**GOVERNMENT OF PUERTO RICO
PUBLIC SERVICE REGULATORY BOARD
PUERTO RICO ENERGY BUREAU**

CASE NO.: NEPR-MI-2021-0009

SUBJECT: Responses to LUMA's questions
and comments on the Avoided EE Cost
Study and scheduling a Technical
Conference.

RESOLUTION AND ORDER

Figure 1: Renewable Generation (% of total generation)

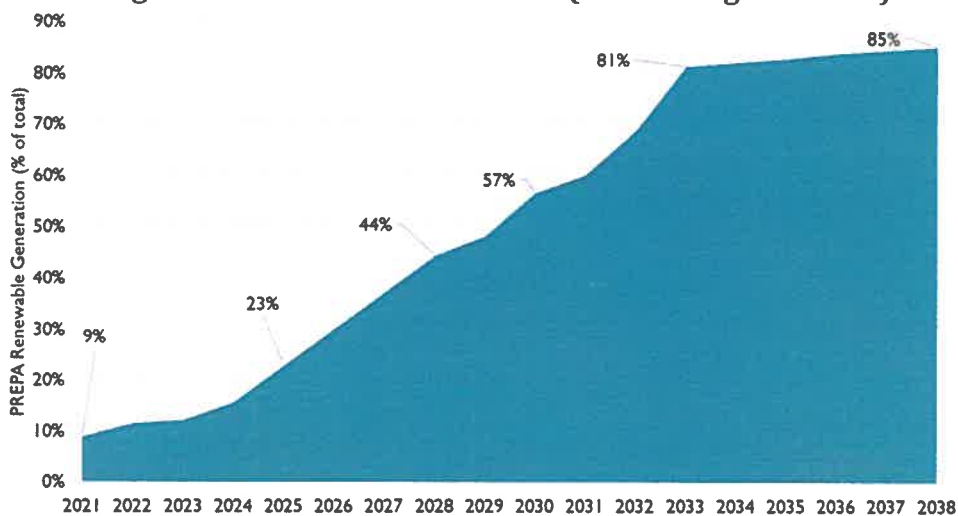
This extrapolation of RPS for the No EE schedule assumes a linear increase according to the new law in Act 17-2019 and is not reflective of the likely actual schedule. The extrapolation should use a stepwise schedule in the first few years that reflects a realistic schedule.

LUMA notes that the results do not seem to reflect the schedule presented on slide 31 for solar.

We agree with LUMA's comment regarding the RPS extrapolation. To better reflect the procurement delays and the general "lumpiness" involved with procuring solar and batteries, Energy Bureau staggered the allowed buildout of solar and batteries.

As an example, Table 4 below (which focuses on the solar build), shows no immediate builds in the next few years. The net impact of this approach has been that the proportion of renewable generation over time follows a non-linear trajectory as seen in Figure 1, and under the "no EE" scenario, falls short of meeting the 2025 requirement shown in Table 3.

Please see Energy Bureau’s response to question 10; Energy Bureau interprets this comment to suggest that the solar schedule is insufficient to meet the RPS target in 2025. Given procurement delays, Energy Bureau believes that within the context of a No EE case PREPA is unlikely to meet the 2025 RPS target. This discrepancy is noted and discussed in our response to question 10.
